APPLICATION FOR PERMIT CHANGE

Title of Change: RESPONSE TO U.D.O.G.M. DIVISION ORDER ACT/007/001-95A

Permit Number: ACT/007/001

Mine: WHITE-OAK MINE COMPL. PERMITTEE: WHITE-OAK MINING & CONSTRUCTION CO. INC.

Drawing No. **R645-301-231.300**
 Scale: 1" = 100' SHEET 4 of 4

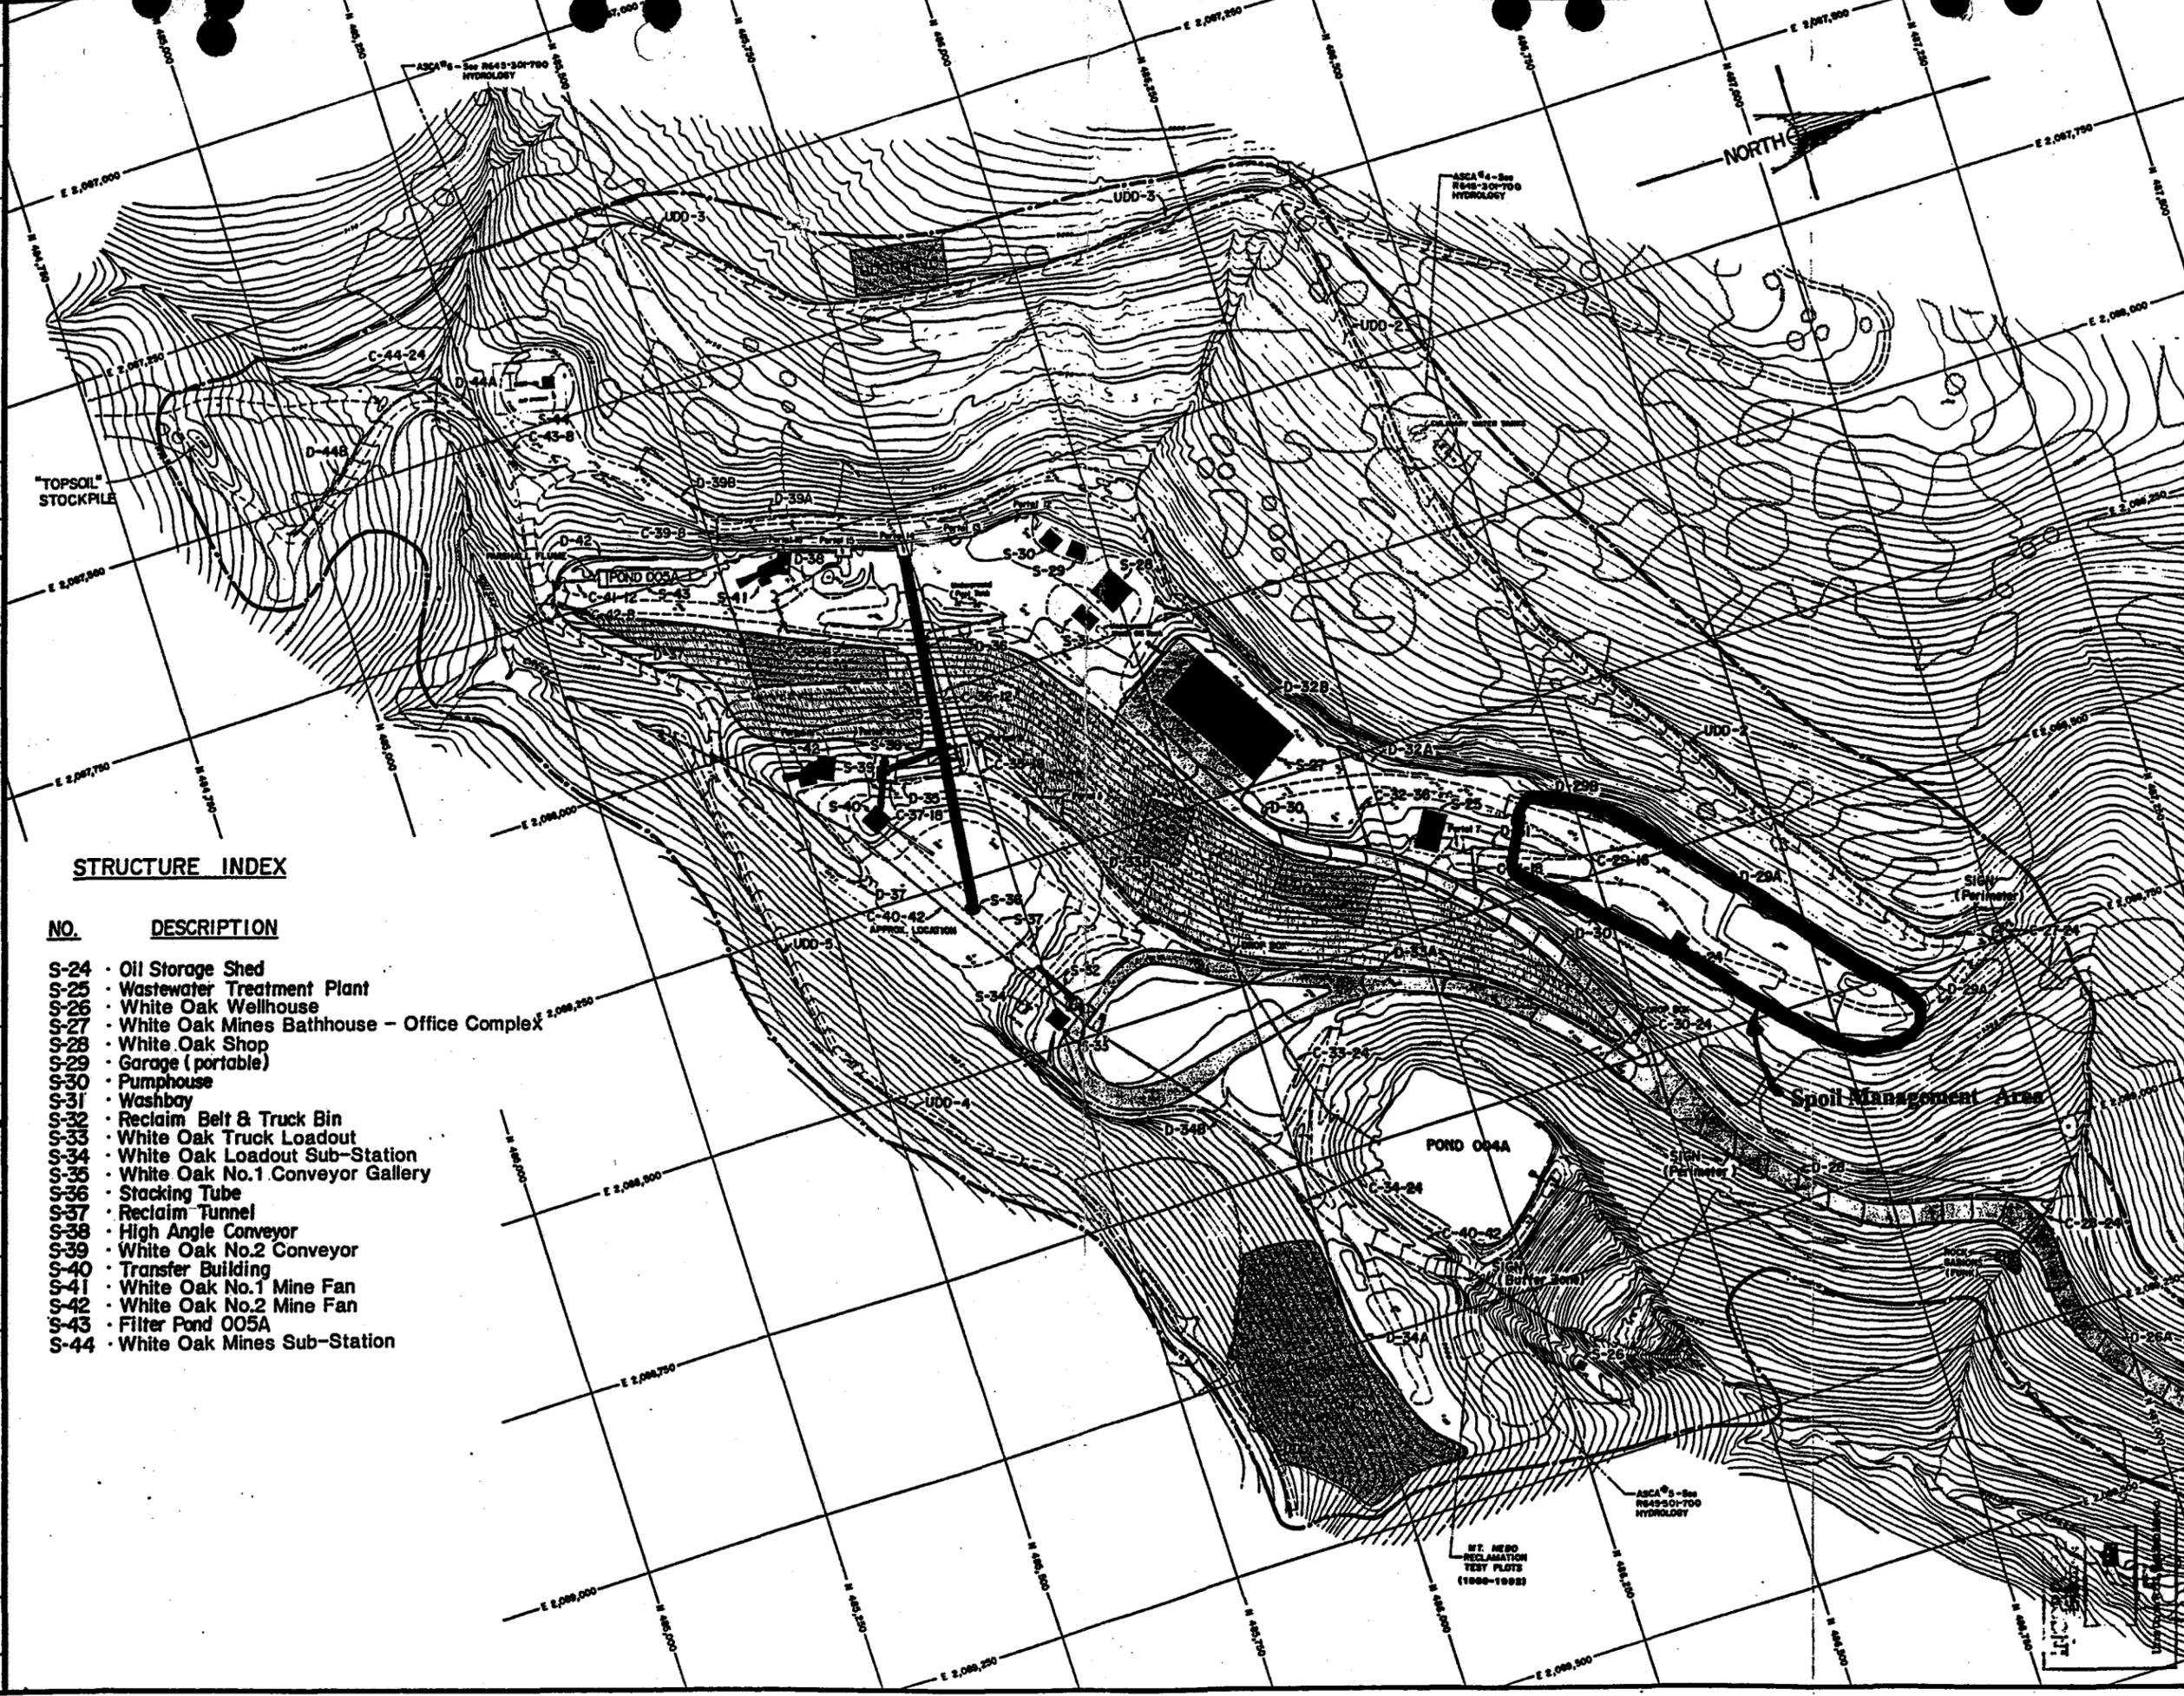
Spoils generated within the Disturbed Area will be taken to the upper pad area east of S-25 which is labeled "Spoil Management Area" on Map R645-301-231.300, Sheet 4 of 4 of the MRP. This area will be used for temporary storage, curing or drying, sampling, blending, gradation, and segregating of materials. Analyses of the spoils will be run prior to placement. Each lift will be placed and compacted in a controlled manner. The fill material will only be placed on cut in this area and will be designed to attain a minimum long-term static safety factor of 1.5. The finished slope will not exceed the natural undisturbed slopes above and below the subject area as shown on Drawing No. R645-301-527, Sheet 12 of the MRP. Certified "As Built" drawing will be submitted when final grade is reached. The initial fill will start near N 486,400 and E 2,08,8375 and will carry easterly until it catches natural or stable material.

The road through this area will remain until reclamation is completed and will be used to remove the equipment following reclamation. Culvert C-29-16 and Ditch D-29A will both be relocated as shown on Map R645-301-231.300, Sheet 4 of 4 of the MRP. The easterly end of the pad will remain as a riprap storage area, until further notice. Ancillary support supplies for ground maintenance work may be stored adjacent to the riprap from time to time. The spoil material may also be utilized elsewhere within the disturbed area for routine maintenance.
